SD4HW & SD4FHW DVR “Delay Time” Issue

**AFFECTED: SD4HW, SD4FHW
As well as their Reseller Designation versions**

**FIELD SERVICE MEMO #52
Issue Date
March 24, 2023**

Alarm Setting Sub Menu is illustrated below.

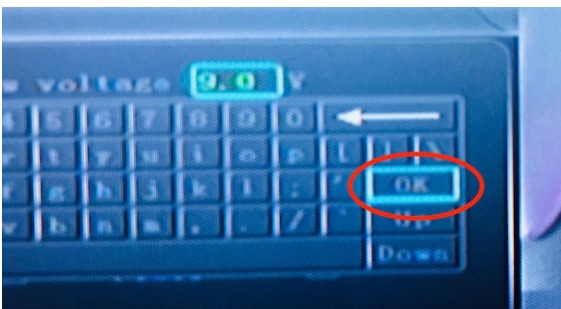
Topic	SD4HW & SD4FHW “Delay Time” function fails to keep DVR powered up after user set time threshold is met.
Problem	DVR default voltage is 24V so “low voltage” is defined as 20.0V DC.
Customer Complaint	Customers may notice their DVR is not recording post ignition, may shut down immediately when the vehicle is turned off or may constantly reboot seeking a appropriate power source.
Manufacturer Notice	On March 22nd, 2023 ABV was informed by a customer that the “Delay time” feature was not functioning properly. After getting the serial numbers from the customer we contacted the manufacture to let them know of the problems.
ABV Actions Taken	<p>ABV technician pulled several DVRs from inventory stock and tested them on the bench to verify the “Delay time” setting in them worked properly. They did not operate properly and the DVRs shut down immediately after the +12V power for Ignition was removed.</p> <p>We notified the manufacturer Product Development Team that we had replicated the customer reported problems with new units in inventory.</p> <p>The Development tTeam requested the “Sys Info” from the problematic DVRs and ABV tech provided Serial Numbers and screenshot of “SYS Info” screens to reflect the version firmware in the DVR. After product testing with proper firmware installed in test DVRs, the manufacturer Development team confirmed the same results.</p> <p>Approximately 24 hours later the Development Team requested we check the Alarm sub menu setting for “Low Voltage”. We reported a “20.00”, meaning the DVR default was set to stop working at +20v DC, which is a problem when working on a 12v DVC vehicle.</p> <p>This highlighted the problems cause and provided a immediate solution, offered below:</p> <p>Due to this change we wanted to create this Service Memo to let customers know of this difference, also printed on all new Quotes, should they not be made aware of this in some other way.</p>

The Solution is a simple change of the Shut Down voltage in the Alarm Menu.

In the DVR Menu, Select Alarm.

Once you have erased the “20.0” setting using the large arrow on the top left of the popup keyboard, set the Low Voltage to “9.00” Select “OK” on the right of the popup keyboard.
